Addendum #1

**Port of Port Arthur
Truck Queuing Area and Laydown Yard
Rider 37 Project 1 – CSJ 0920-38-288**

Addendum Date: August 21, 2025

SHEET TITLE	
RAIL PLAN/GRADE CROSSING PANELS & FENCING PLAN	
PROJECT	
RIDER 37 — PORT OF PORT ARTHUR TRUCK QUEUING AREA AND LAYDOWN YARD	
221 HOUSTON AVENUE PORT ARTHUR, TEXAS 77641

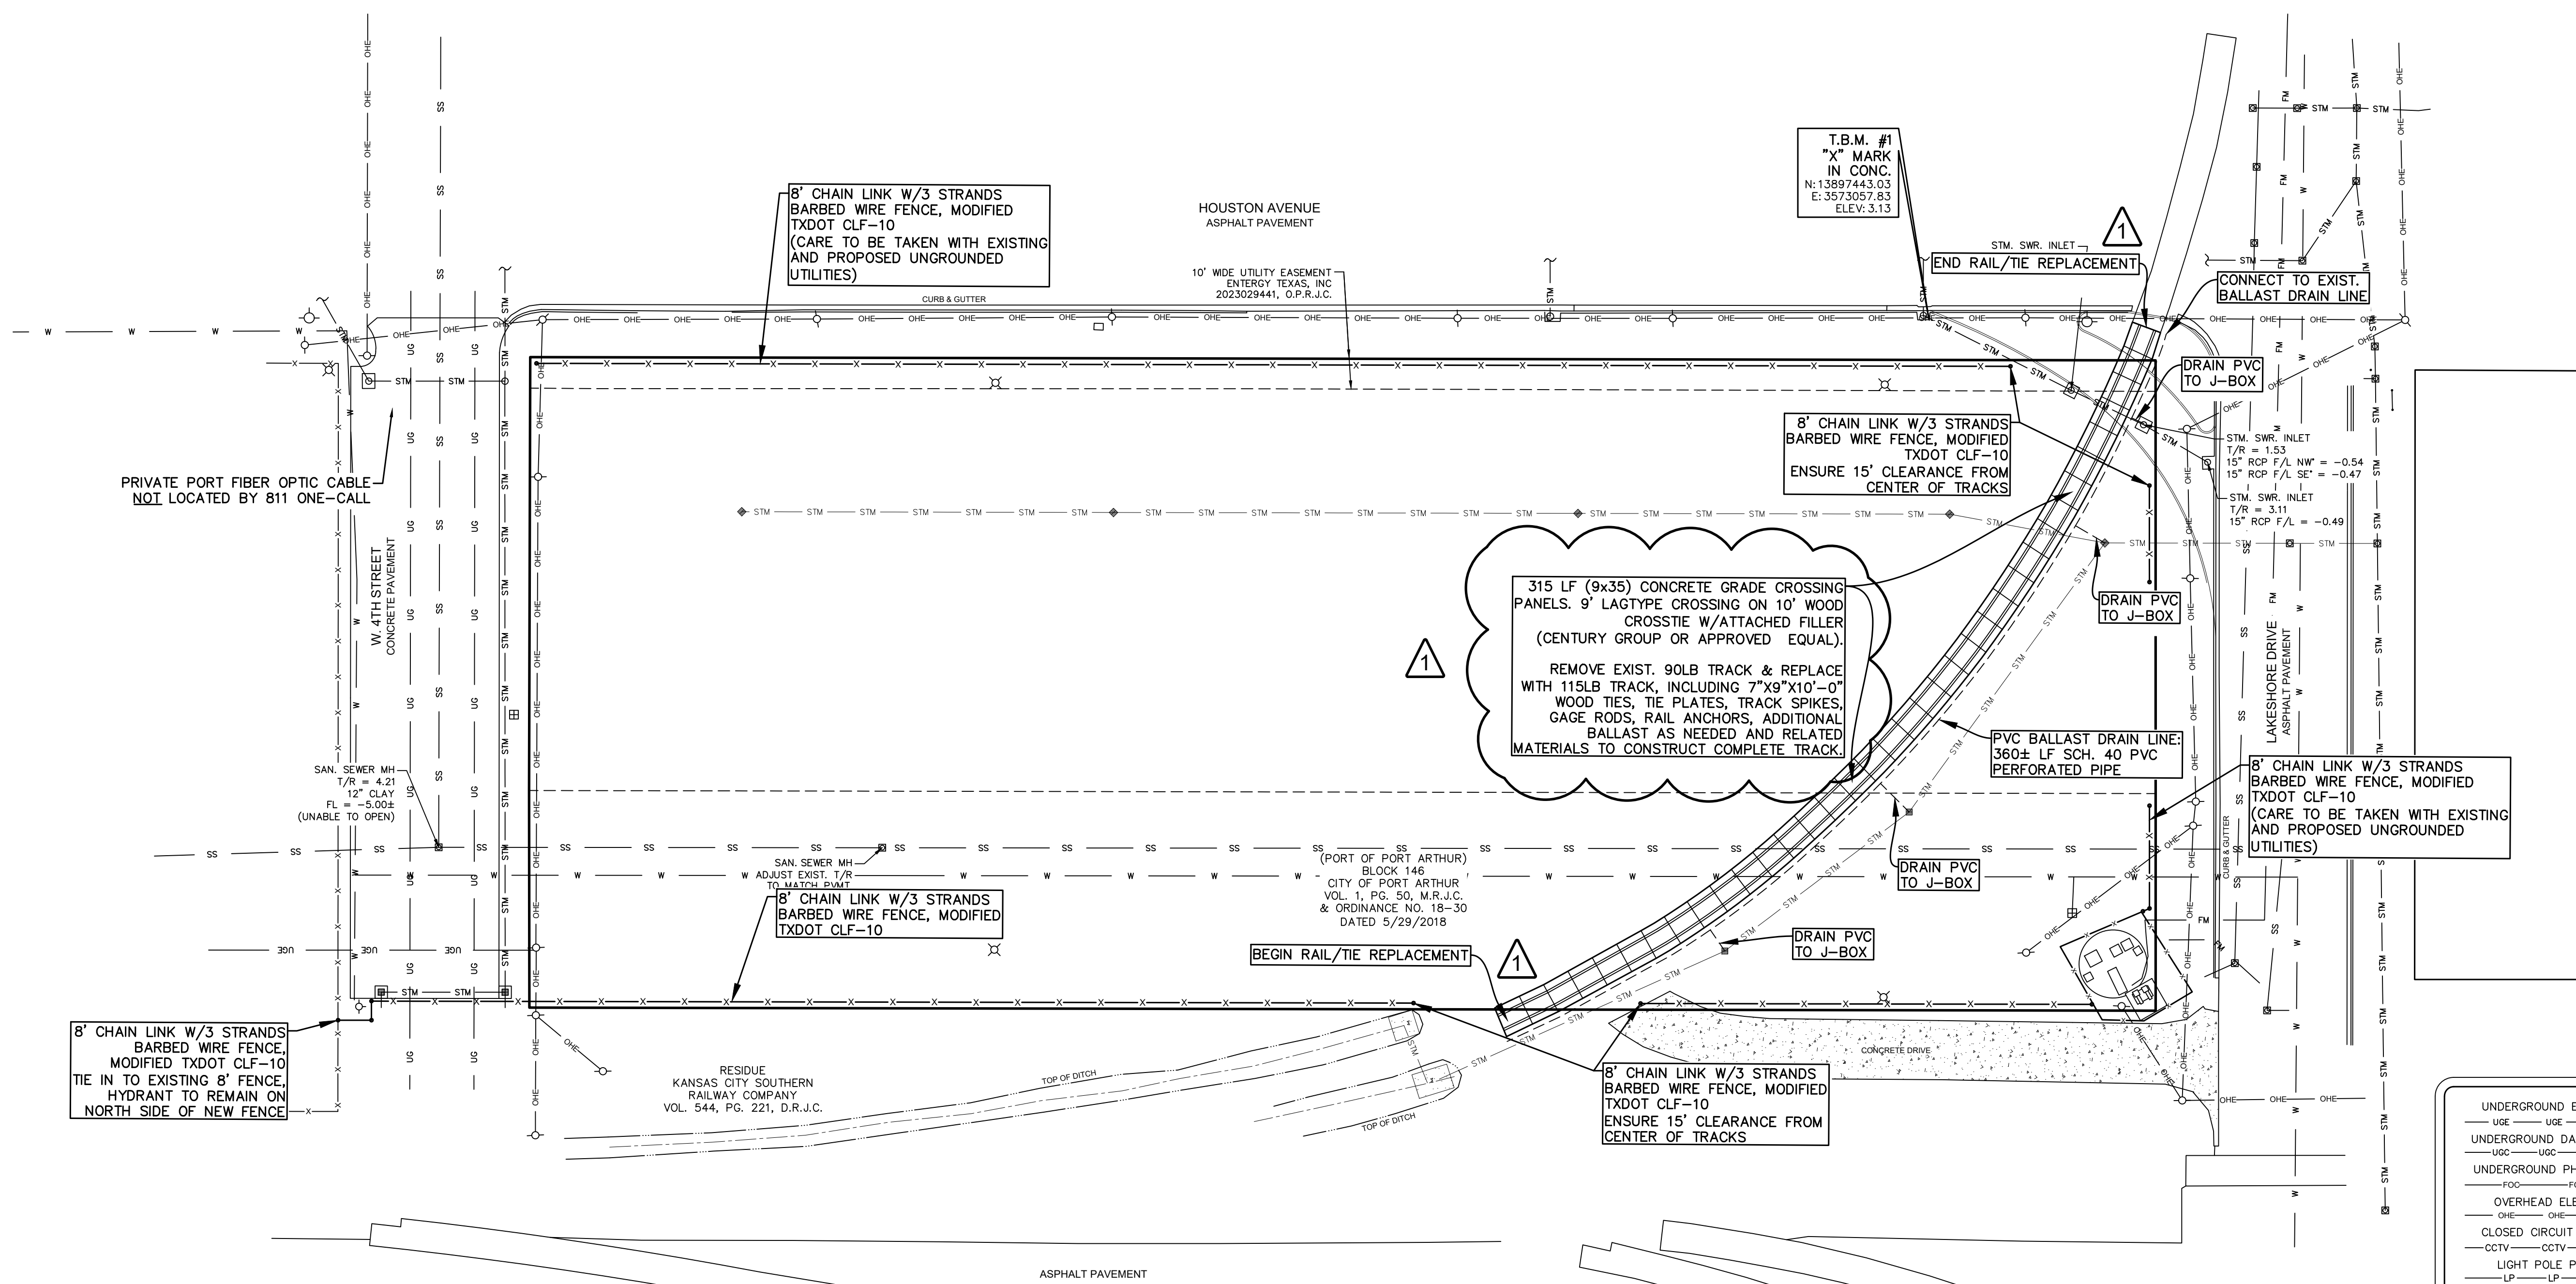
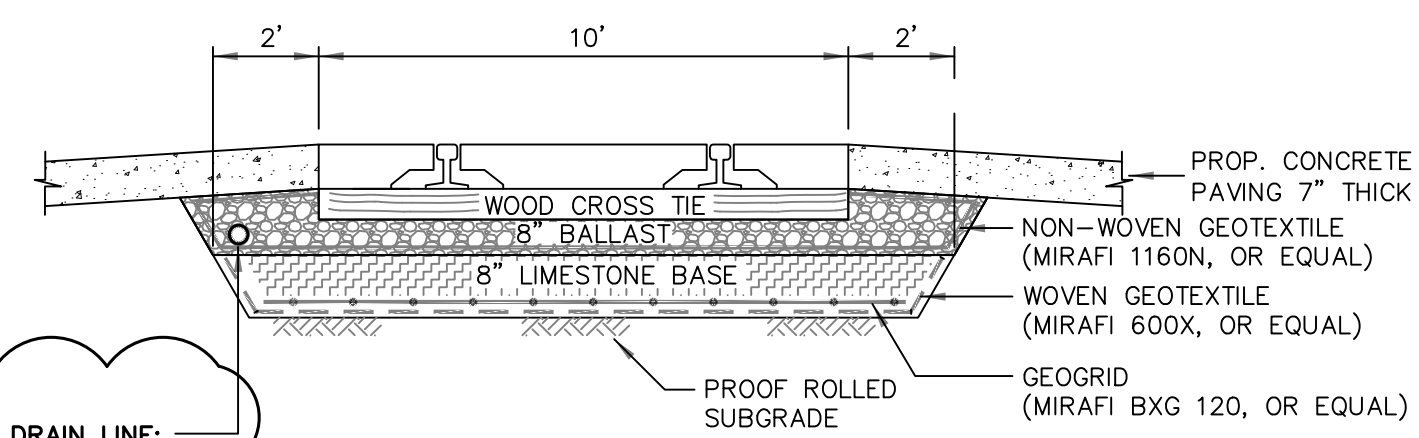
1. Bid items added (Demolition, Railroad Items, Traffic Control, etc.)
2. Steel casing around storm lines below rails, A36 standard wall thickness, smallest size necessary, no spacers. (30" steel on 24" hp, 24" steel on 18" hp) (sheet 8).
3. Rail work added to scope, remove and replace rails and ties (sheet 9).
4. Curb detail (sheet 13).

NO.	REVISION NOTES	DATE
1	ADDED TO SCOPE OF RAIL WORK	8/20/2025

SHEET TITLE
UTILITY PLAN
PROJECT
RIDER 37 - PORT OF PORT ARTHUR TRUCK QUEUING AREA AND LAYDOWN YARD
221 HOUSTON AVENUE
PORT ARTHUR, TEXAS 77641

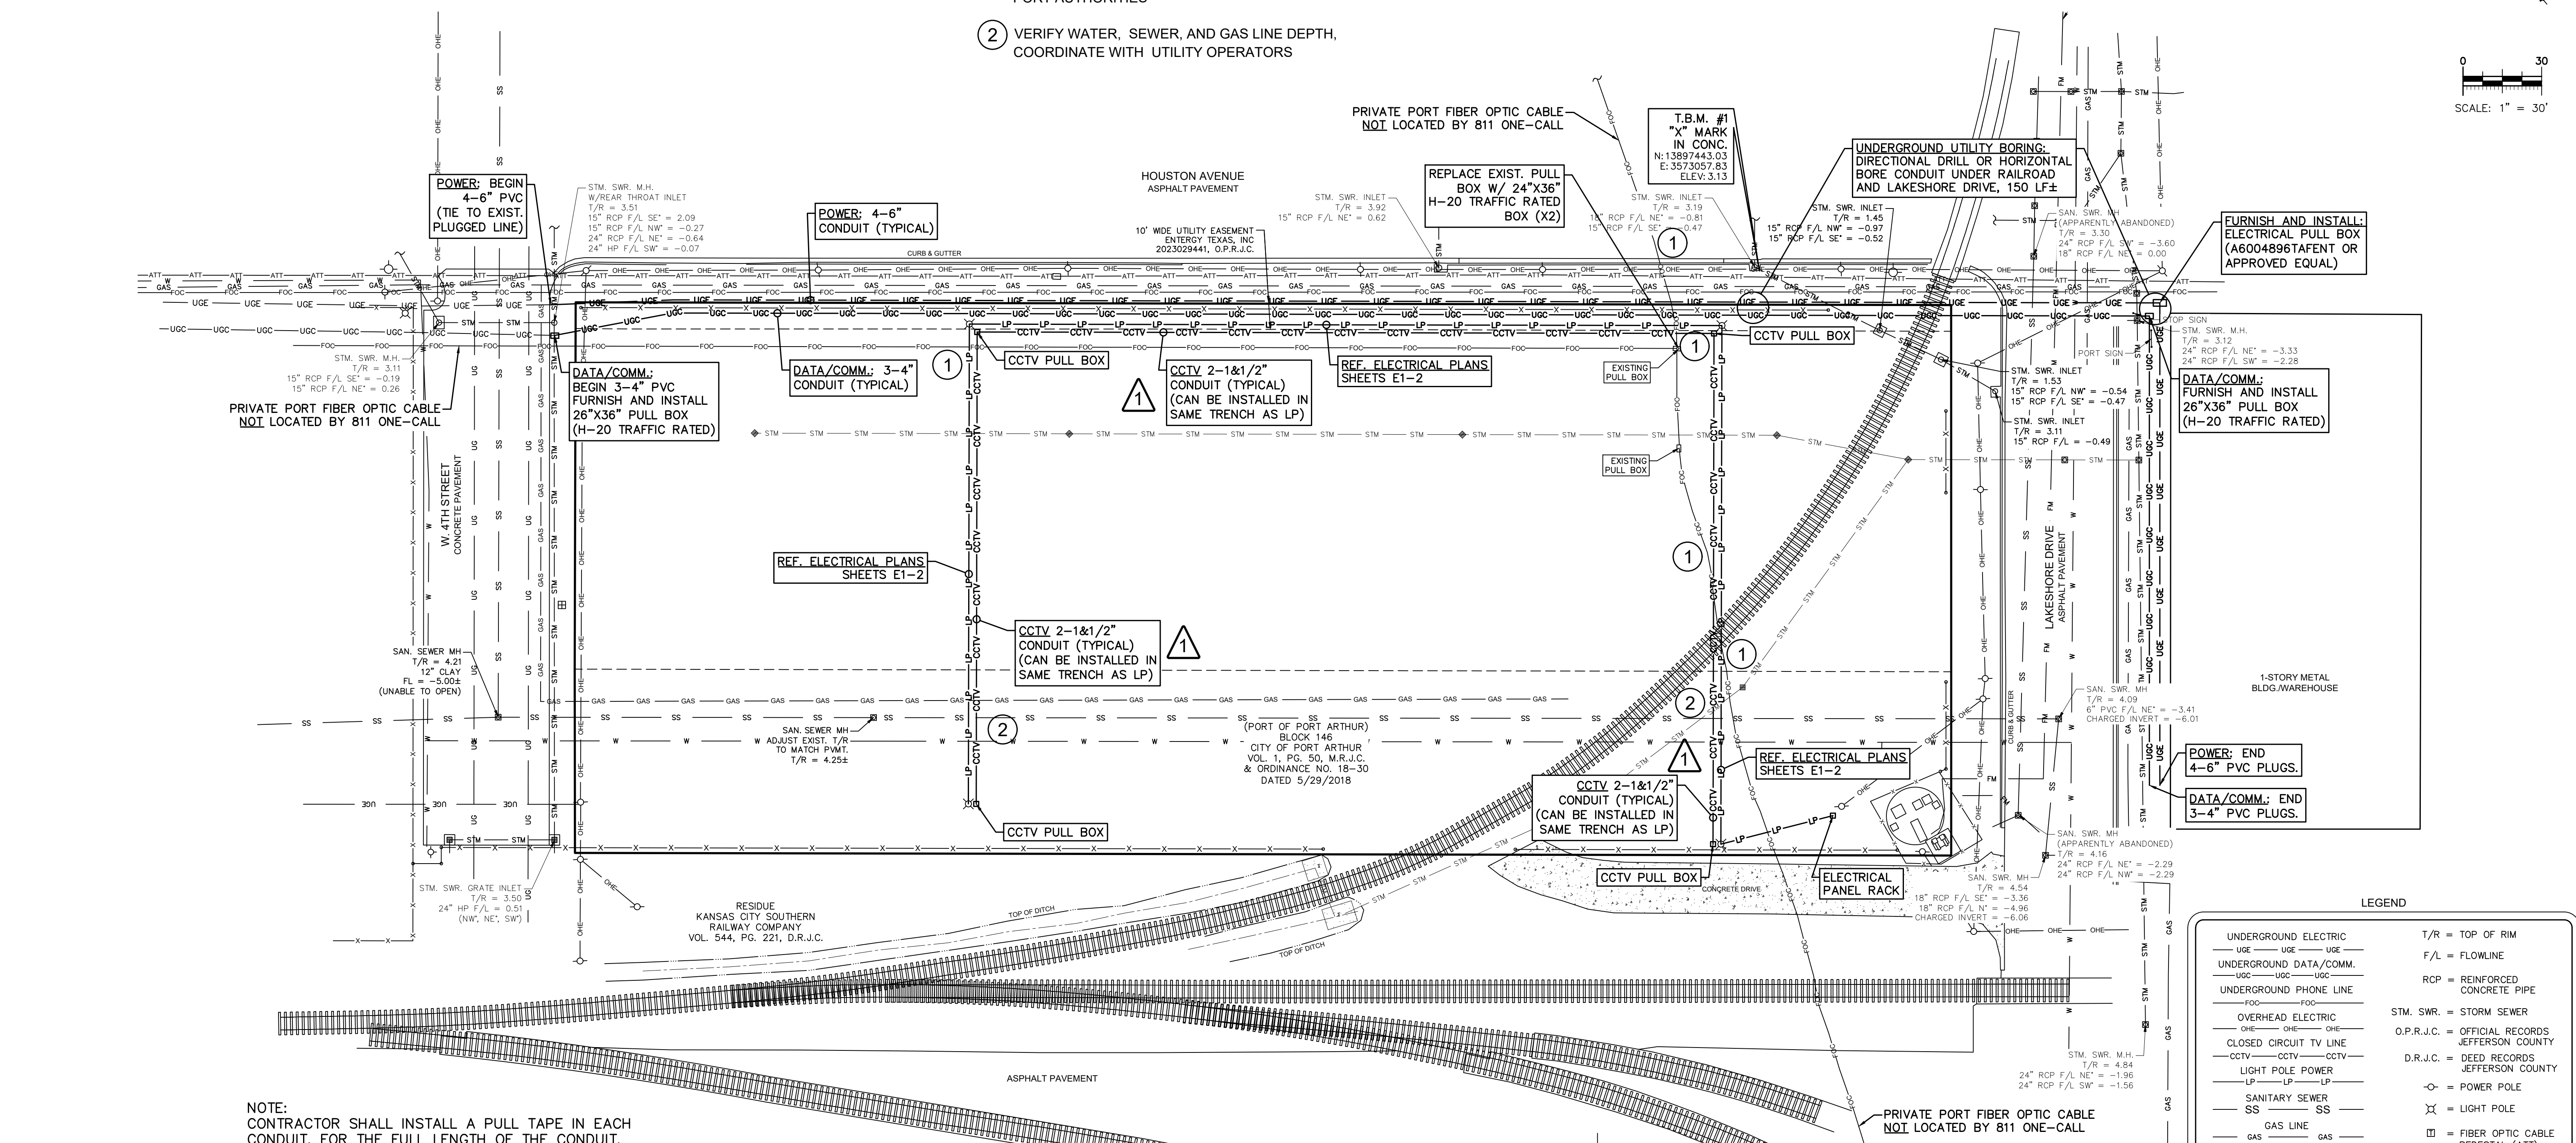
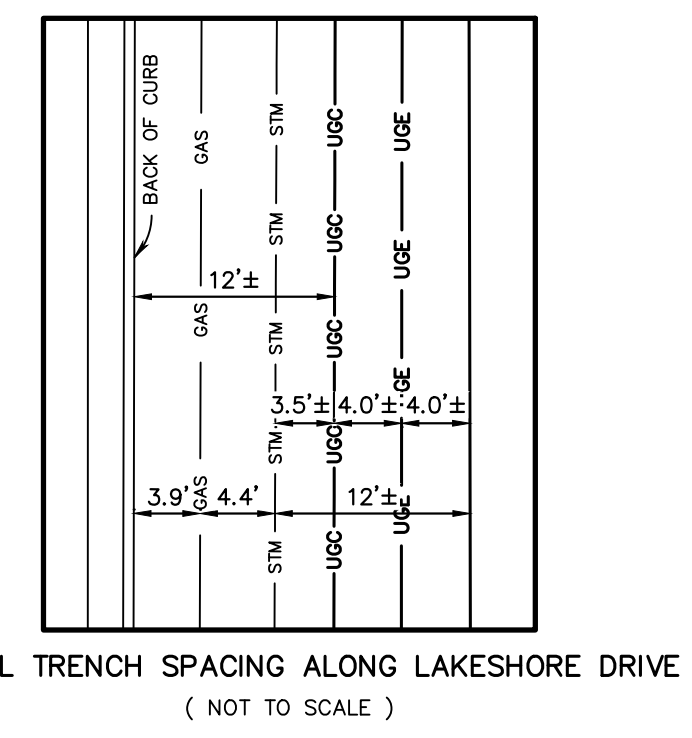
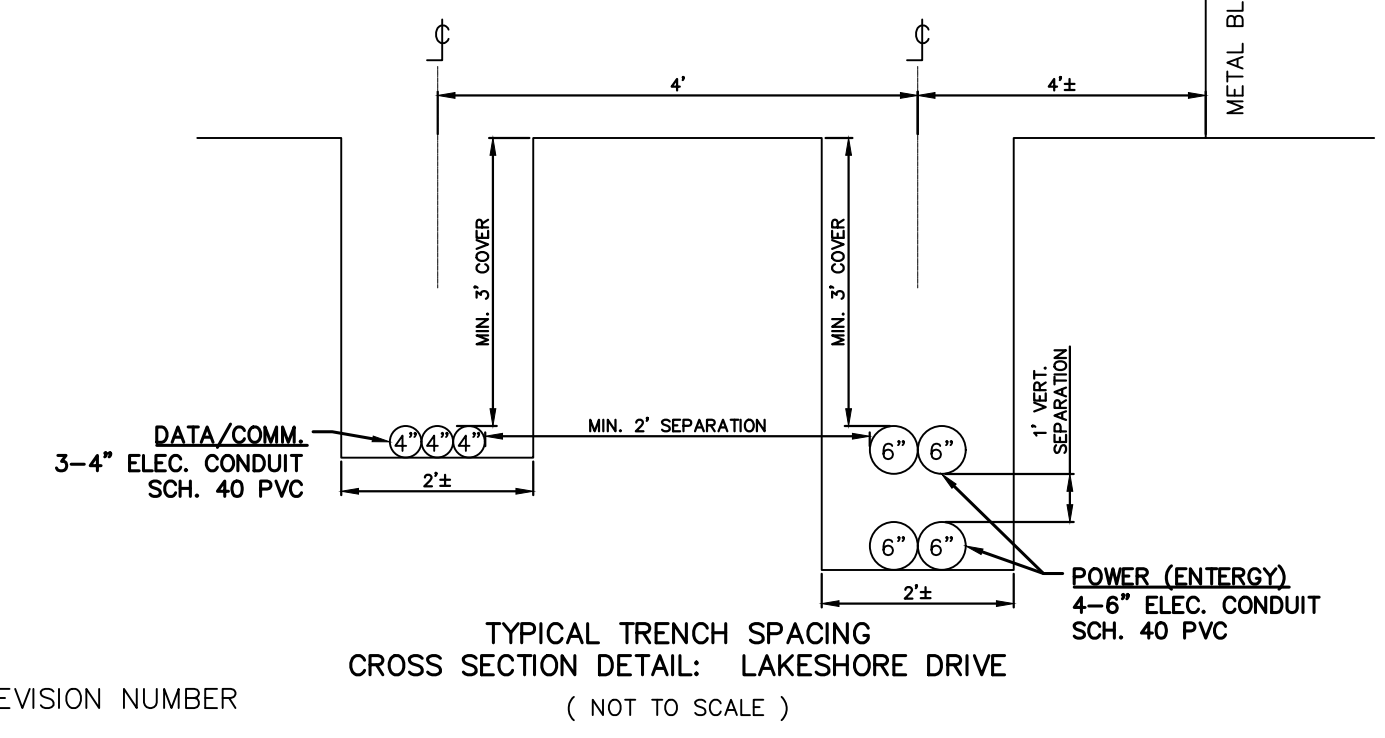
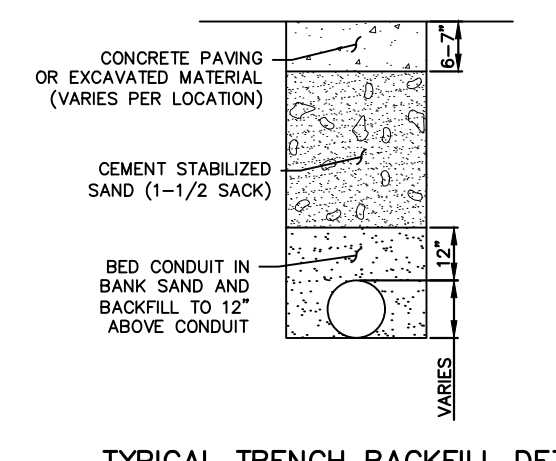
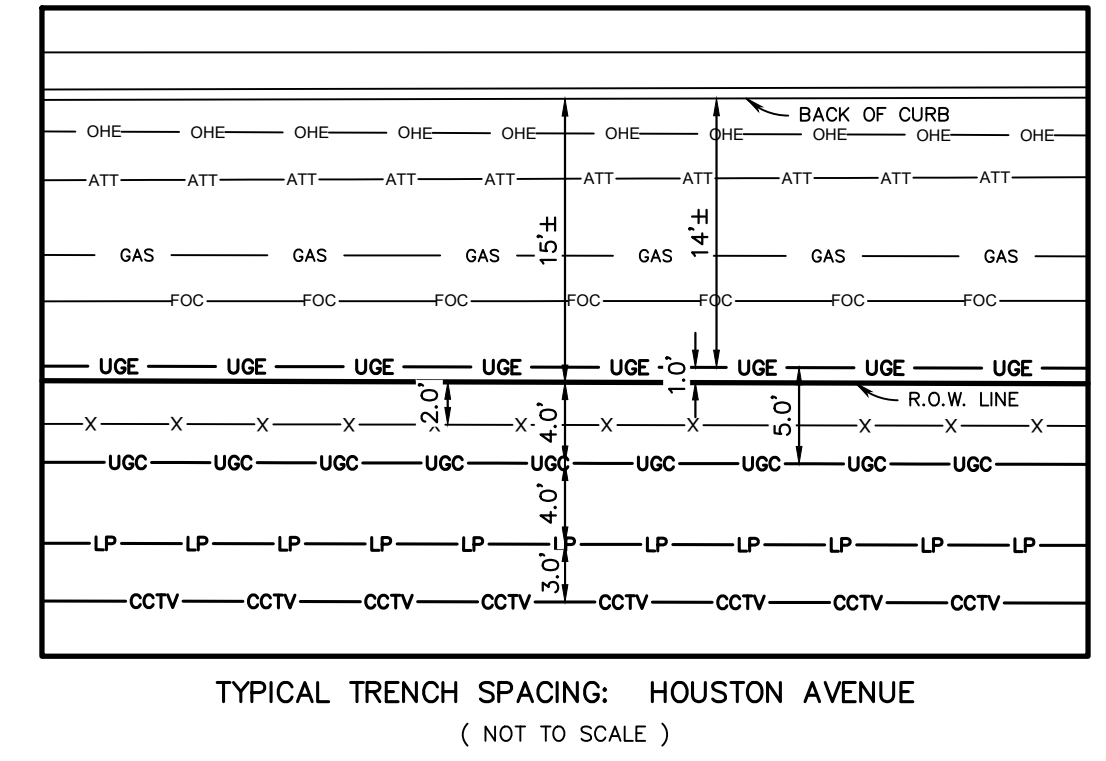
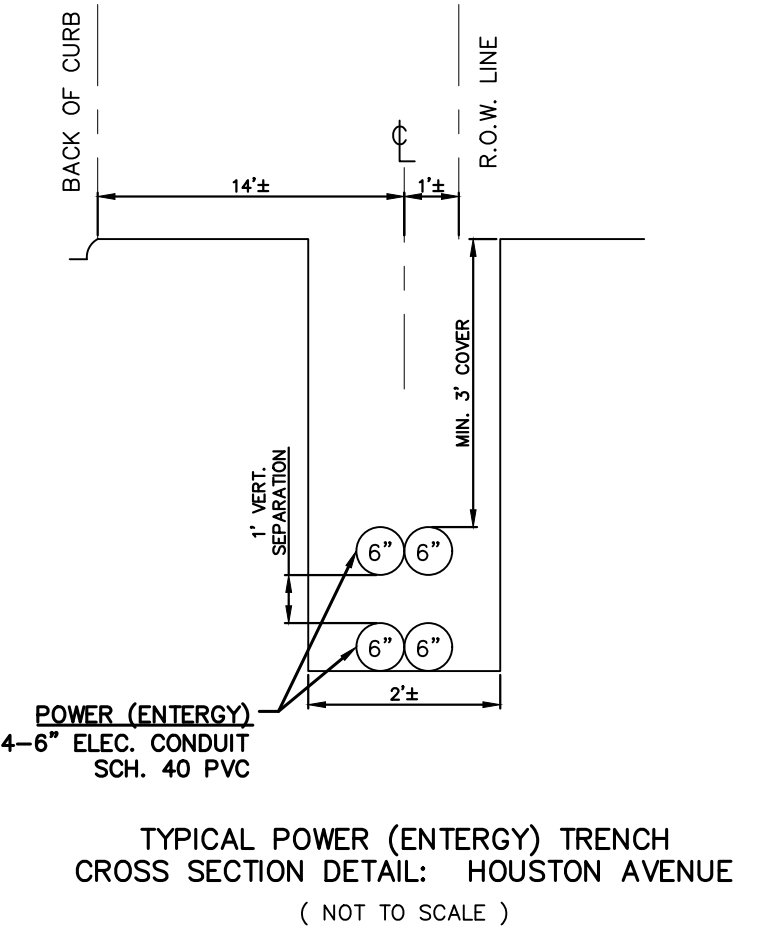
1. Demolition Plan updated to note buildings removed by port (sheet 4).
2. Turn Lane clarified as concrete paving with no asphalt (sheet 5).
3. Clarify trench details for CCTV (sheet 10).
4. Fencing details modified, top rail and bracing clarified, no bottom rail. Tension

NO.	REVISION NOTES	DATE
1	CLARIFY TRENCHING DETAILS FOR CCTV	8/20/2025
